UNITED STATES PATENT AND TRADEMARK OFFICE

APPLICATION NO.	FILING DATE	FIRST NAMED INVENTOR	ATTORNEY DOCKET NO.	CONFIRMATION NO.
10/582,074	03/16/2007	Peter Quirk	HAC-104US	1552
23122	7590	02/18/2010	EXAMINER	
RATNERPRESTIA			FONSECA, JESSIE T	
P.O. BOX 980			ART UNIT	
VALLEY FORGE, PA 19482			PAPER NUMBER	
			3633	
			MAIL DATE	
			DELIVERY MODE	
			02/18/2010	
			PAPER

Office Action Summary	Application No.	Applicant(s)	
	10/582,074	QUIRK, PETER	
	Examiner	Art Unit	
	JESSIE FONSECA	3633

DETAILED ACTION

Fig. 5: Weir (US 5,148,644)

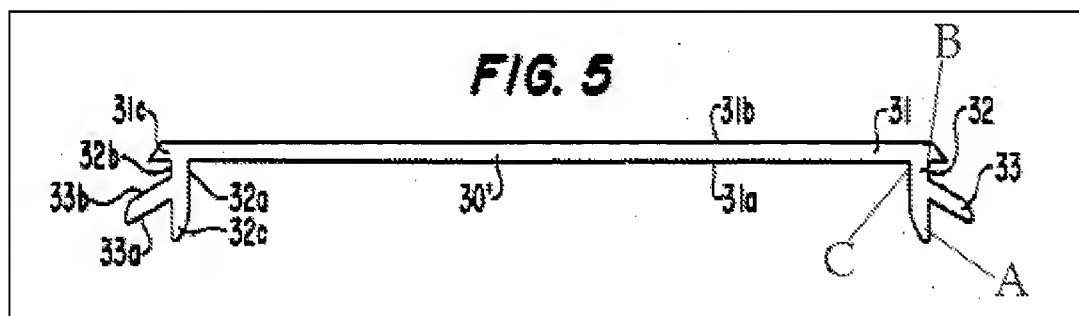
With regard to claim 1: Weir discloses flashing (30') comprising an elongate body capable of overlying a member, and the flashing further comprising legs (A) extending for at least part of the body length and protruding from either side of the body (fig. 5)

With regard to claim 2: Weir further discloses two legs (A) extending for the entire length of the body on opposing sides thereof (figs. 57).

With regard to claim 4: Weir further discloses wings (31C) extending laterally from the body beyond the legs (A) (figs. 5 & 7).

With regard to claim 5: Weir further discloses the wings (31C) extend for the entire length of the body on opposing sides thereof (figs. 5 & 7).

With regard to claim 7: Weir further discloses the wings (31c) have an elongate rectangular shape on the bottom face of the wings and are respectively joined to the body along opposing elongate sides thereof (fig. 5).

With regard to claim 8: Weir further discloses each wing (33) tapers, from a relatively thicker section where it is connected to the body to a relatively thinner remote end (fig. 5).

Fig. 8: Sykes (WO 91/13221)

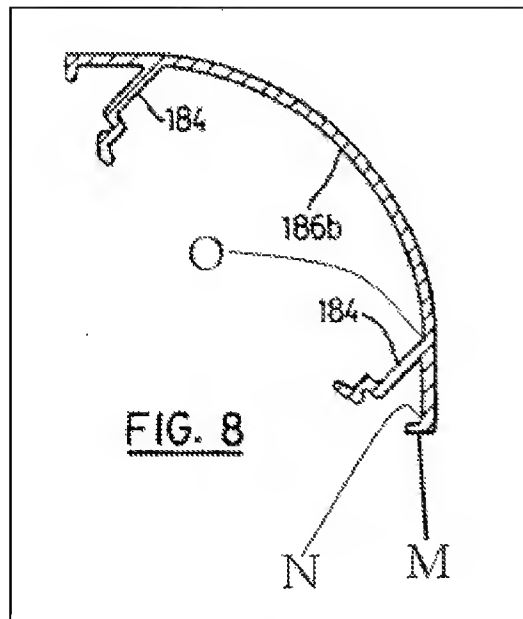
With regard to claim 1: Sykes discloses “flashing” (186b) comprising an elongate body capable of overlying a member, and the flashing further comprising legs (184) extending for at least part of the body length and protruding from either side of the body (fig. 8; pg. 11, lines 15-28)

With regard to claim 2: Sykes further discloses two legs (184) extending for the entire length of the body on opposing sides thereof (fig. 8).

With regard to claim 3: Sykes further discloses prior installation, the legs (184) on opposing sides of the body project generally towards each other (fig. 8).

With regard to claim 4: Sykes further discloses wings (M) extending laterally from the body beyond the legs (184) (fig. 8).

With regard to claim 7: Sykes further discloses the wings (M) have an elongate rectangular shape and are respectively joined to the body along opposing elongate sides thereof (fig. 8).

With regard to claim 9: Sykes further discloses a line (O) provided along and adjacent to where each leg is attached to the body (fig. 8)

With regard to claim 10: Sykes further discloses the body has an elongate rectangular shape from the perspective of top view (fig. 8) similar to that of applicant's.

With regard to claim 17: Sykes discloses “flashing” (186b) comprising an elongate body for overlying a member, and legs (184) protruding from either side of the body and extending for at least part of the body length (fig. 8).
